UNITED STATES
DEPARTMENT OF THE INTERIOR
BUREAU OF LAND MANAGEMENT

SUNDRY NOTICES AND REPORTS ON WELLS
Do not use this form for proposals to drill or to re-enter an abandoned well. Use form 3160-3 (APD) for such proposals.

8. Well Name and No.
SEMU MCKEE 11

9. API Well No.
30-025-07846-00-S2

WELLBORE SKETCH
 ConocoPhillips Company -- Permian Basin Business Unit

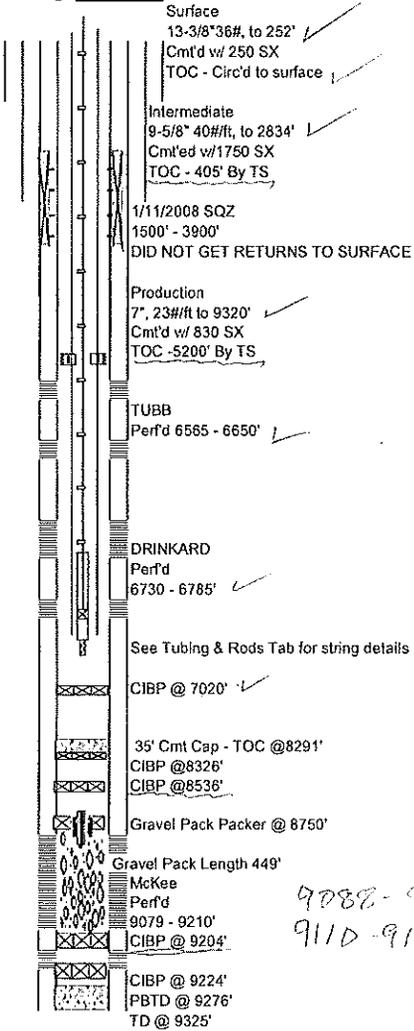
Drill out CIBP @ 7020, clear out to 7700

- MIRU, POOH w/ Prod Equipment
- Set CIBP @ 6465'. Circ hole w/ MLF. Pressure test casing. *7700 (T-straw)*
- Spot 40sx cmt @ 6465'-6260' *7700-7520. WOC Tag.*
- Spot 80sx cmt @ 5647' - 5235' *(T-Gloria)*
- Perf/Sqz 50sx cmt @ 4090' - 3990'. WOC-Tag *3950*
- Perf/Sqz 50sx cmt @ 3824' - 3724'. WOC-Tag *3885-3745*
- Perf/Sqz 50sx cmt @ 3500' - 3400'. WOC-Tag *3370*
- Perf/Sqz 130sx cmt @ 2928' - 2577'. WOC-Tag *Add plug. Perf @ 1630, SQZ cmt to 1530*
- Perf/Sqz 100sx cmt @ 302' - 202'. WOC-Tag *Deep penetrating shots. WOC Tag.*
- Perf/Circ 50sx cmt @ 60' - 3' *Deep penetrating shots.*
- Verify cmt @ surface. RDMO. Cut off WH & anchors. Install P&A marker

Below ground level day hole markers required

Handwritten notes:
 1500' - 3900' (SQZ) 2692 - Suct
 1500' to 3900' (SQZ) 2692 - Suct

Handwritten notes:
 9088-9200 Perls
 9110-9174 Perls
